#### **SYDNEY OPERA HOUSE**

#### **LOWER CONCOURSE SHADE COVERS, MINOR WORKS & USES**

#### **SSD-9794 APPROVAL – MODIFICATION 1**

#### **Heritage Impact Statement**

**Figure 4:** Extract from LK drawing DA-135 showing proposed Accessible WC with associated vestibule, and reconfigured vestibule to the Male WCs. Note the alignment of new granite cladding on east wall in relation to mushroom column in the Accessible WC Vestibule. North is to the left of this page.

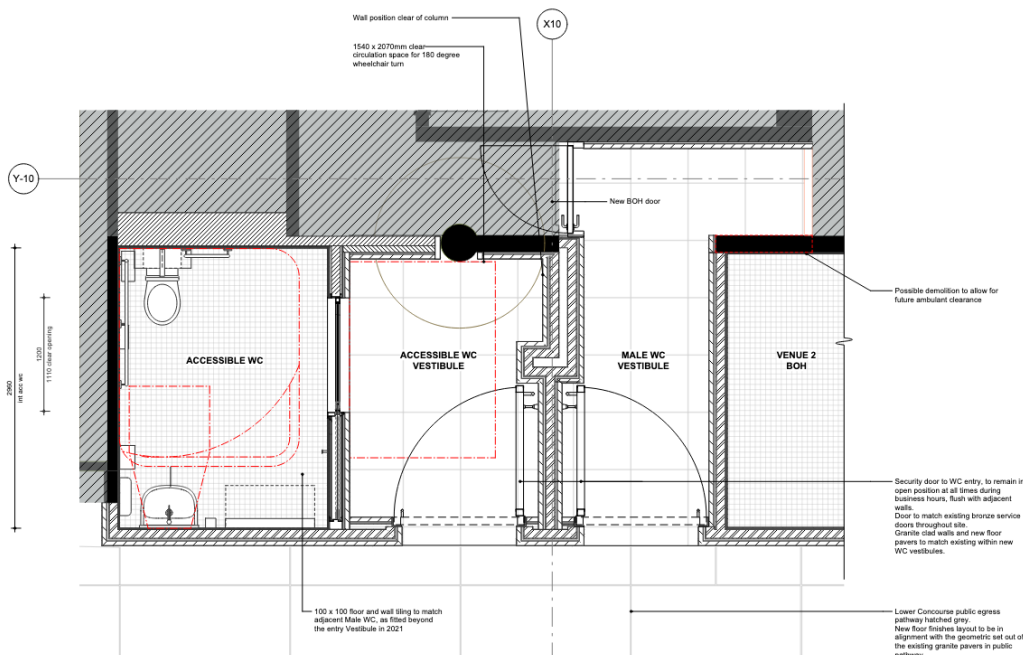
2. LK drawing DA-135 indicates the mushroom column on the east (rear) wall of the accessible WC entry vestibule is to be partially buried within the wall thickness, reducing its visual prominence. The face of the granite cladding on this wall should be set back as close as possible to the centreline of the column to ensure its full semi-circular profile remains fully visible as a key Hall element in this space. Revised detail to be provided to the heritage architect for review and approval before commencement of construction.

LK drawing DA-135 indicates the granite wall cladding on the east (rear) wall of the accessible WC entry vestibule is to be an additional thickness to new and existing walls either side of the mushroom column. This will visually reduce the prominence of this column, 'embedding' it into the wall thickness. The face of the granite cladding should be set back as close as possible to the centreline of the column to ensure it remains fully visible as a key Hall element in this space.

- Visibility of the mushroom columns within the Venue 2 servery area should be increased to reveal as much as possible of their full semi-circular profile, including the mushroom capitals.
- LK drawing DA-135 indicates the mushroom column on the east (rear) wall of the accessible entry vestibule is to be partially buried within the wall thickness, reducing its visual prominence. The face of the granite cladding on this wall should be set back as close as possible to the centreline of the column to ensure its full semi-circular profile remains fully visible as a key Hall element in this space.
- Where new walls abut the mushroom columns, they should be separated by a detail that allows later removal without damage to the concrete surface. These junction details should be provided to the heritage architect for review and approval before works commence.

**Figure 7:** Sectional elevation from LK drawing DA-132 (copied here in two parts) of east side of public walkway showing proposed new configuration of servery to Eatery (Venue 2) flanked by bronze doors to WC facilities.

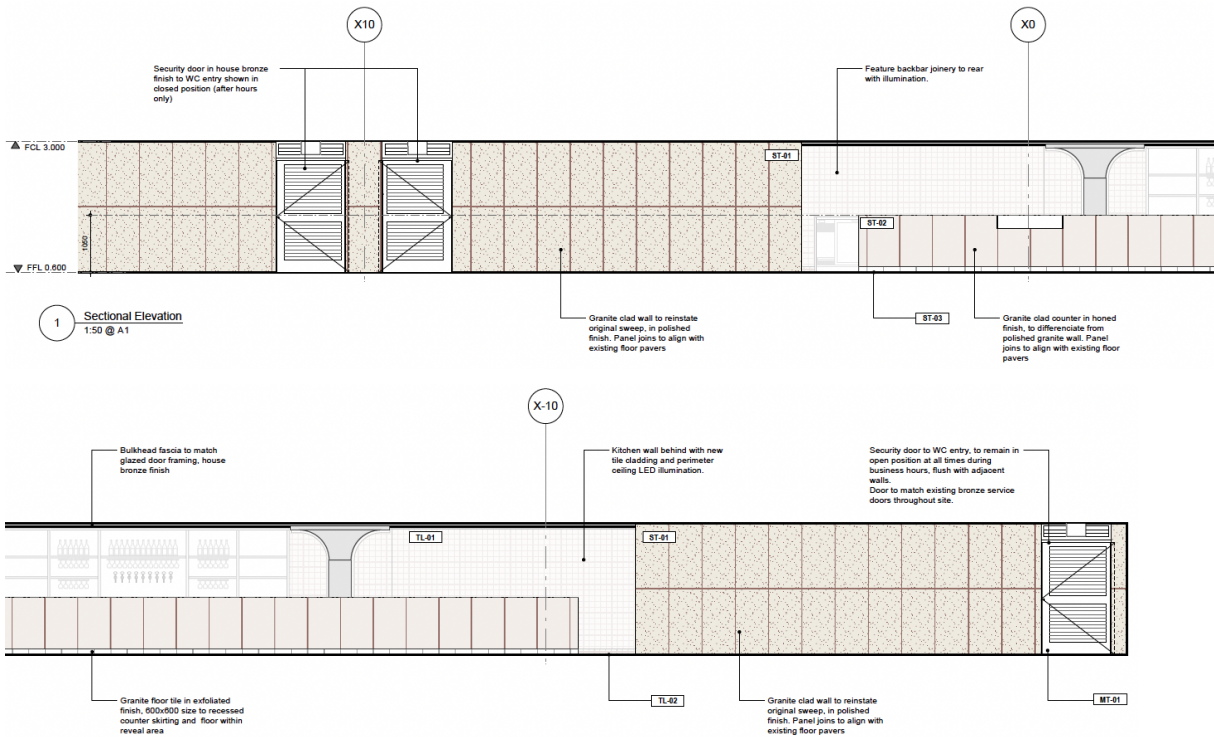
1. The visibility of the proposed partially exposed mushroom columns, including their flared capitals, at the rear wall of the Eatery server area (Venue 2) should be increased on the public side in consultation with the DAP and the heritage architect for review and approval before commencement of construction.
2. LK drawing DA-135 indicates the mushroom column on the east (rear) wall of the vestibule to the accessible WC is to be partially buried within the wall thickness, reducing its visual clarity and prominence. The face of the granite cladding on this wall should be set back as close as possible to the centreline of the column to ensure its full semi-circular profile remains fully visible as a key Hall element in this now public space. Revised detail to be provided to the heritage architect for review and approval before commencement of construction..
